Model Communiqué

Communiqué # 113

ATA 22 Autopilot – G36/G58 Garmin GSM 85 Servo Mount Inspection Service Bulletin

NO.: 0713 Revision B

Figure 4-1

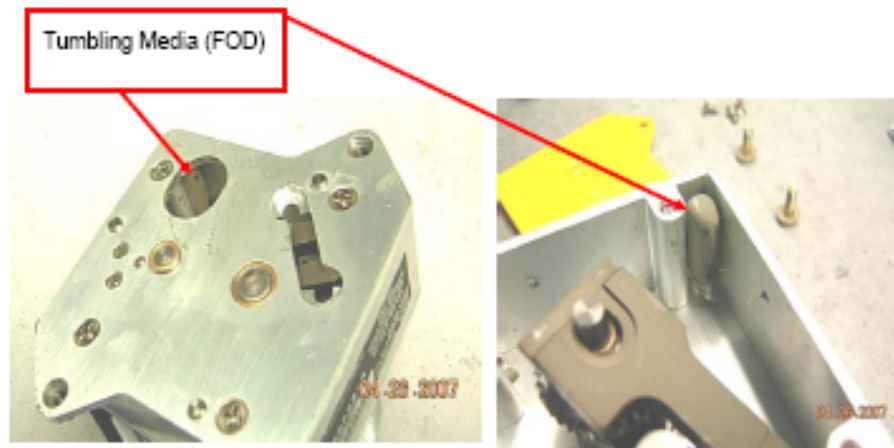
- 4.1 Remove the GSA 8X servo from the GSM 85 per the OEM Aircraft Maintenance Manual.
- 4.2 Insert the borescope into the hole on the bottom side of the GSM 85 where the actuator gear of the GSA 8X servo inserts.
- 4.3 Maneuver the borescope to view all potential areas where foreign objects (FOD) may be present, particularly in the corners of the extrusion (Figure 4-1). Also look closely at the gears for the presence of FOD, rotate the gears to view all potential areas for FOD. FOD may be present anywhere inside of the extrusion, not only where shown in Figure 4-1.

- 4.4 If FOD is present, remove the GSM 85 per the OEM Aircraft Maintenance Manual and return the GSM 85 servo gearbox to Garmin for exchange. After receiving the replacement GSM 85 from Garmin, proceed to Section 6 Reinstallation.

- 4.5 If the borescope inspection produces no conclusive determination regarding the absence of FOD, proceed to Section 5 FOD Inspection by GSM Removal.
- 4.6 If it is conclusively determined that no FOD is present:
- o For GSM 85s part number 011-00894-00 or 011-00894-10 only, mark the MOD 3 circle (on the serial tag) with an indelible marker indicating compliance with this bulletin.
 - o For GSM 85s part number 011-00894-XX (where -XX is other than -00 or -10), mark the MOD 1 circle (on the serial tag) with an indelible marker indicating compliance with this bulletin.
